SPECIFICATIONS AND DRAWINGS
HOUSING AUTHORITY OF THE CITY OF LUMBERTON: TURNER TERRACE
REPAIR OF FLOOD-DAMAGED UNITS
TWC # 3313-B 03

SUBJECT: ADDENDUM NO. 2

MAY 9, 2019

To the Plans and Specifications for:
Housing Authority of the City of Lumberton: Turner Terrace
Repair of Flood-Damaged Units

SHEET NO.
E102

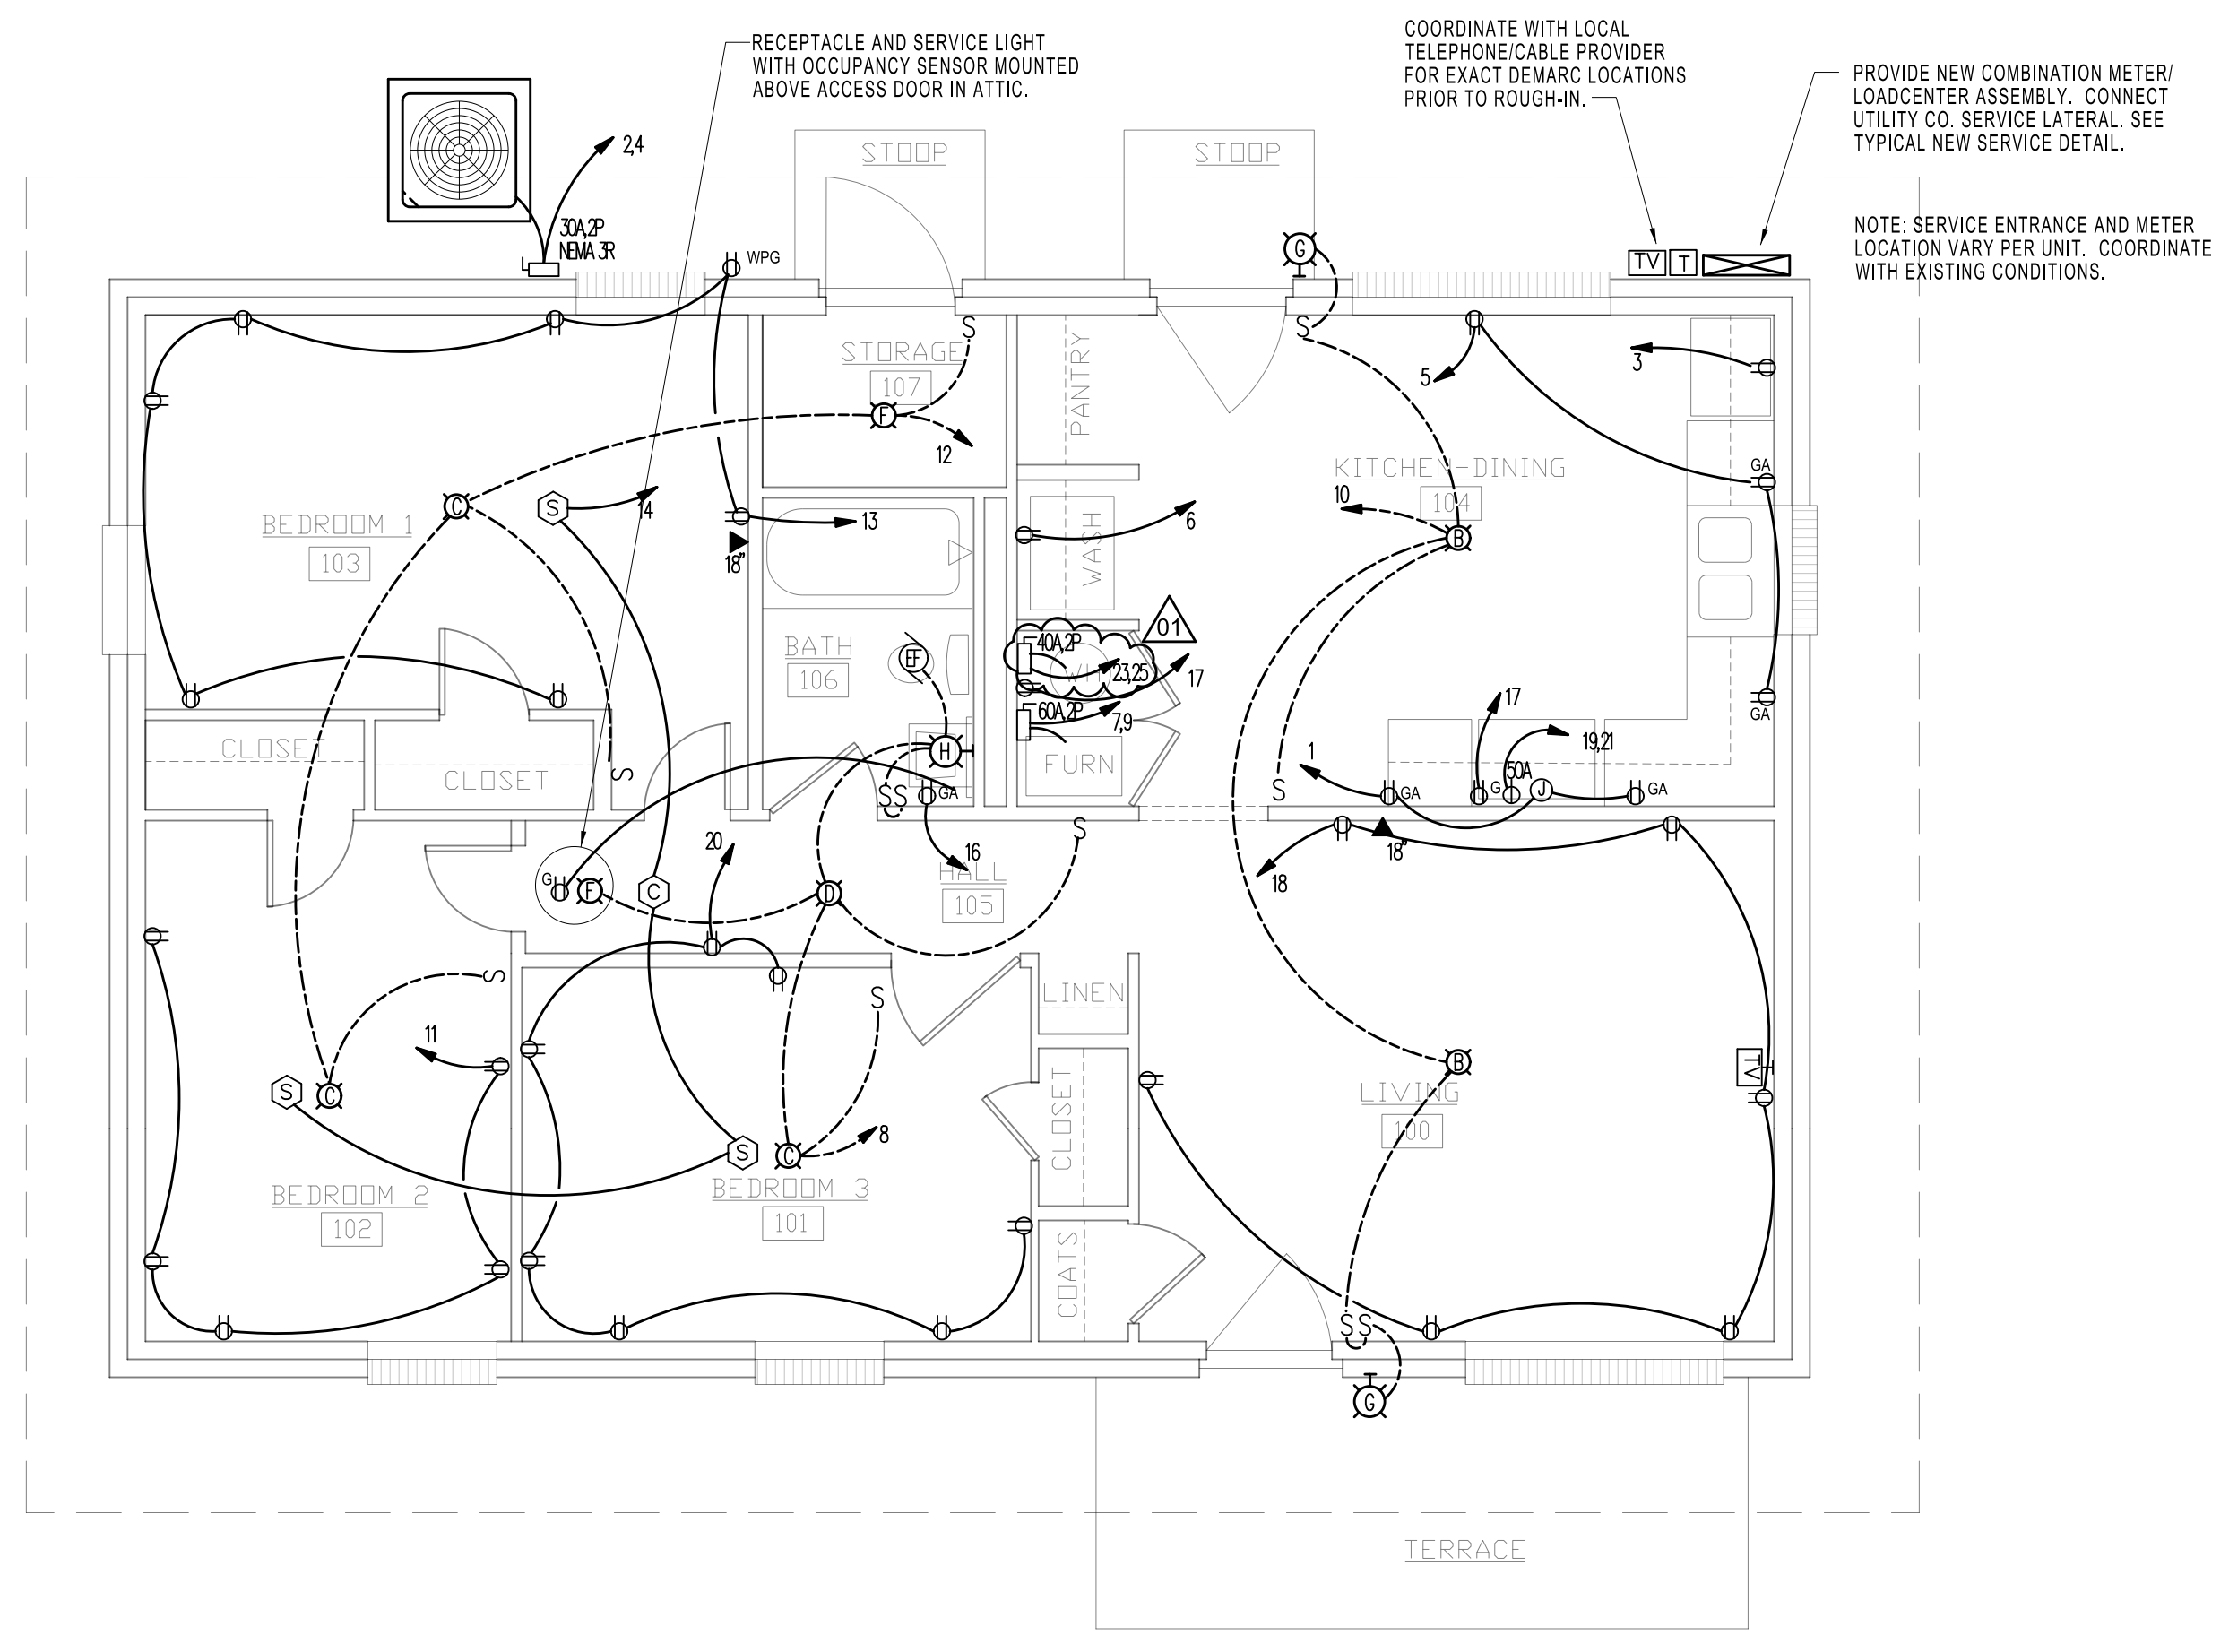
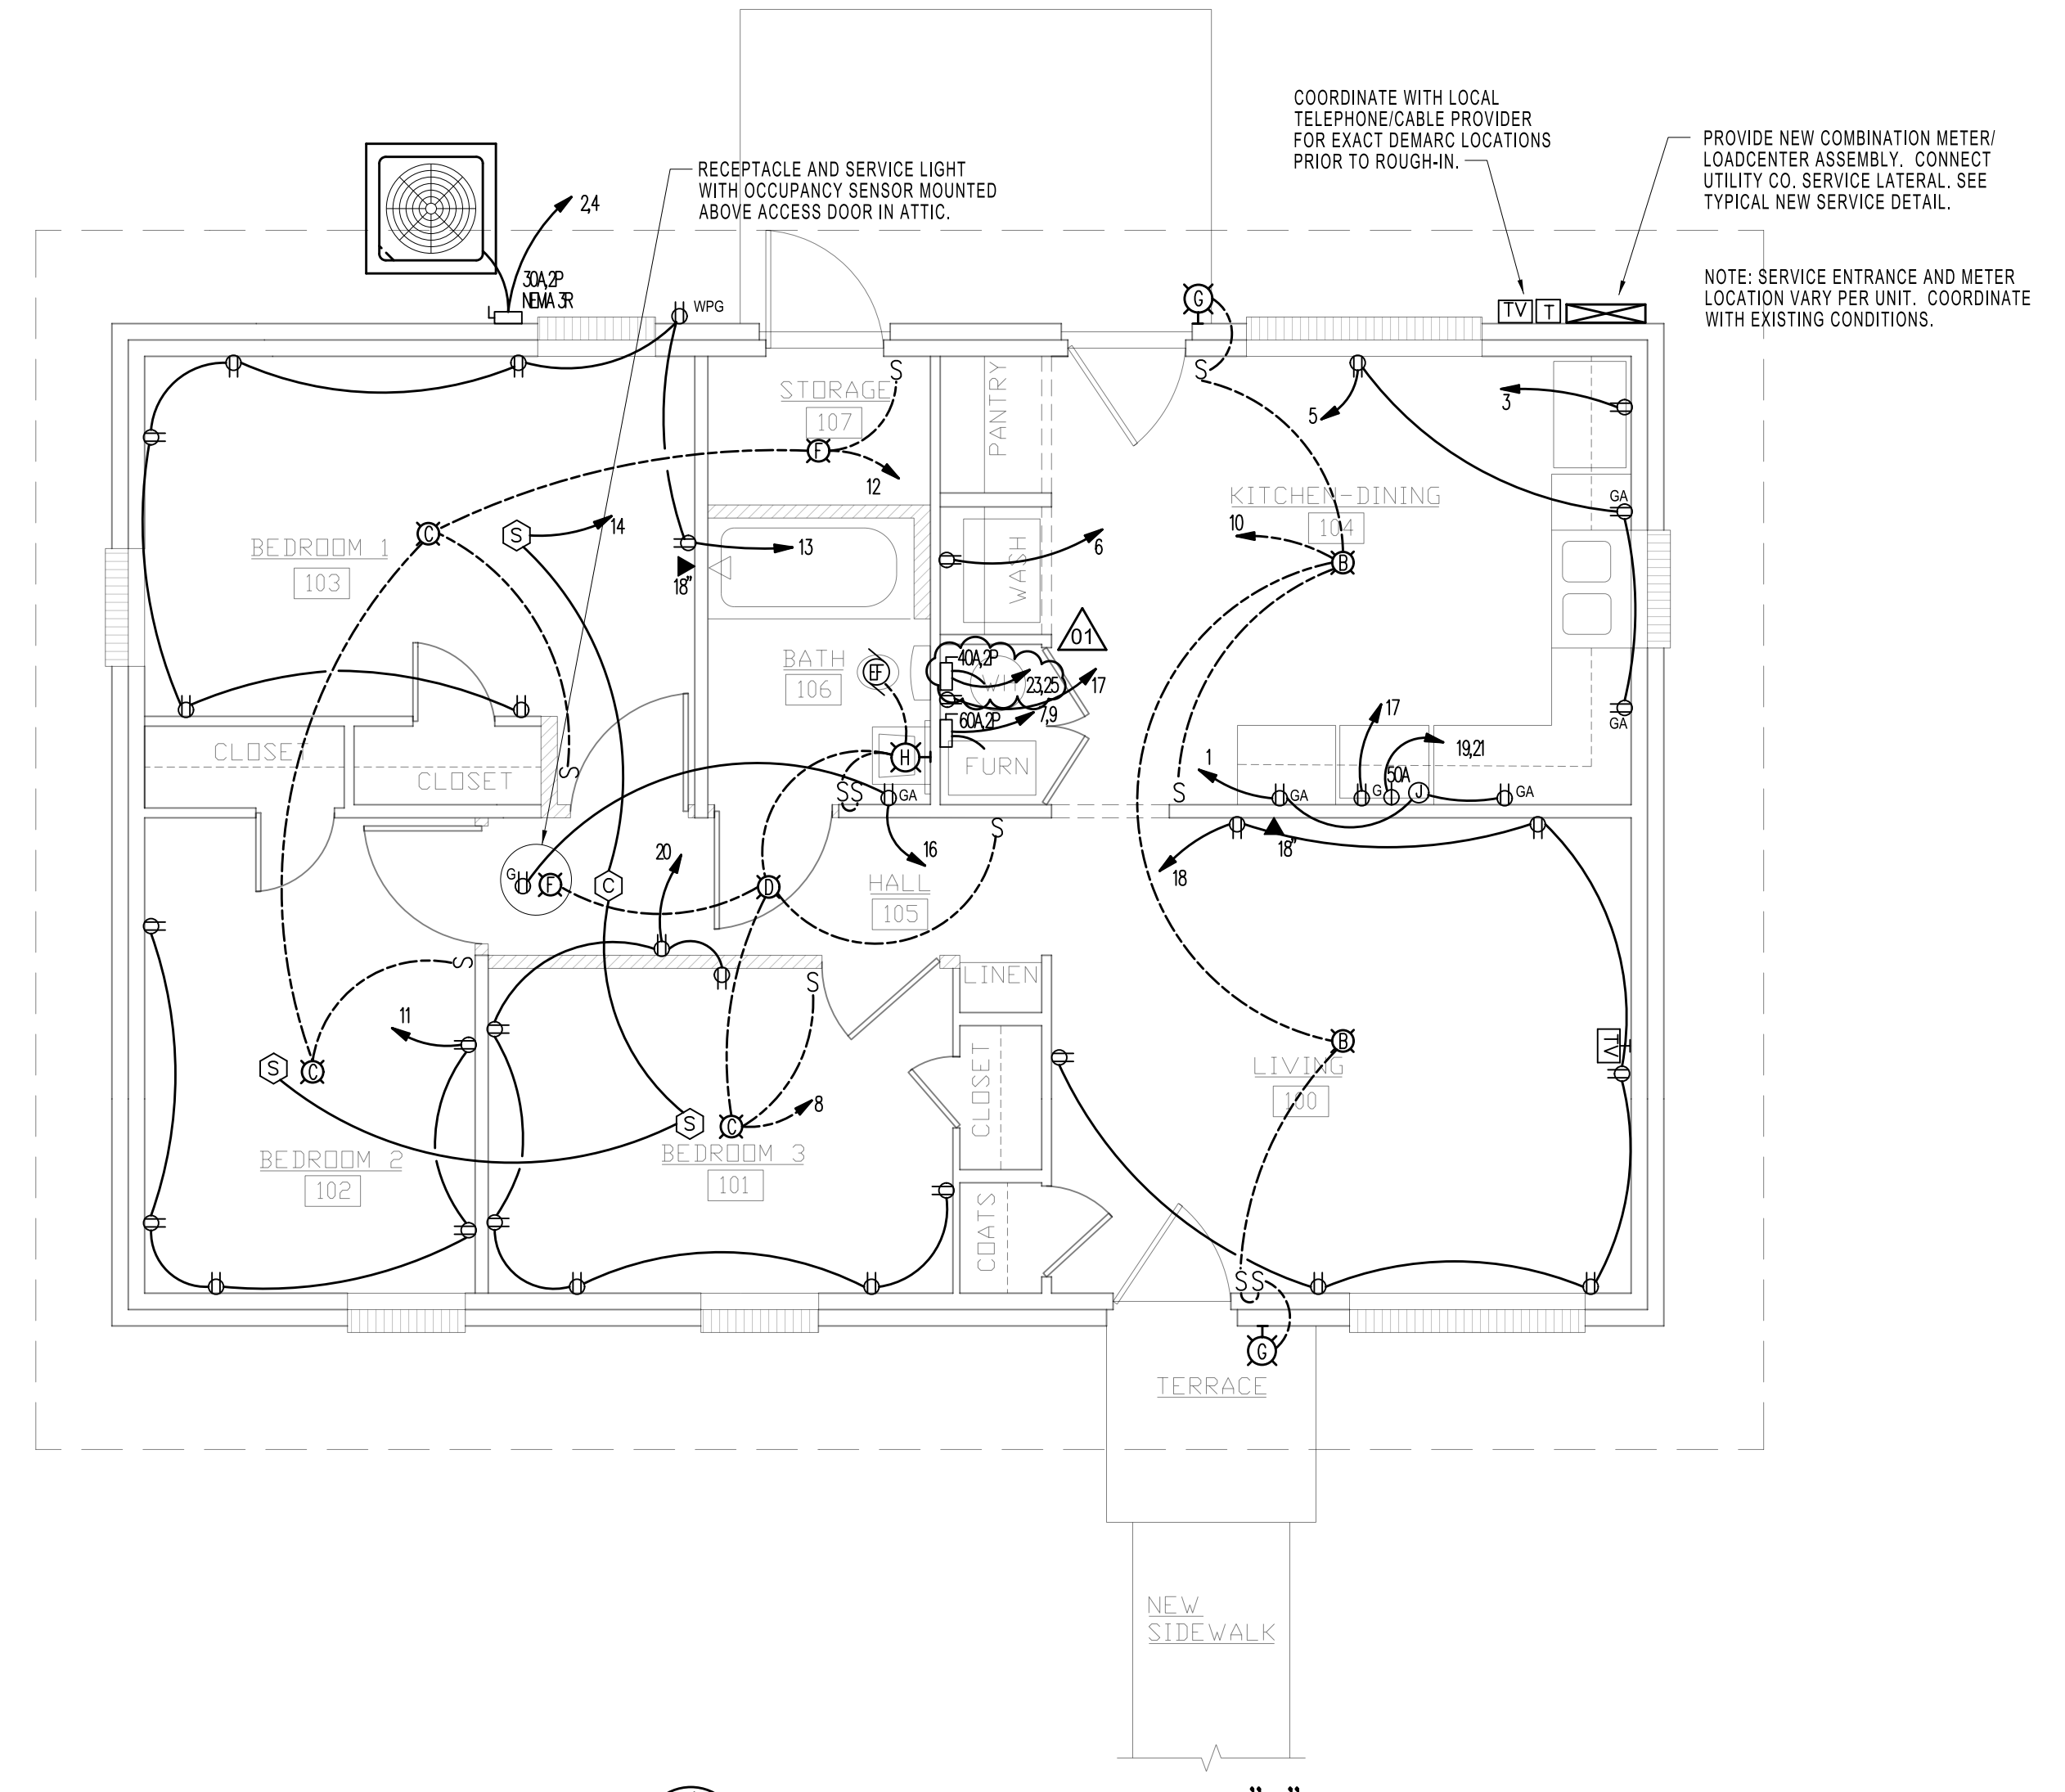
8. Sheet E102
 - a. Replace with attached.
 - b. 1/E102: Add circuit for electrical water heater.
 - c. 2/E102: Add circuit for electrical water heater.
9. Sheet E103
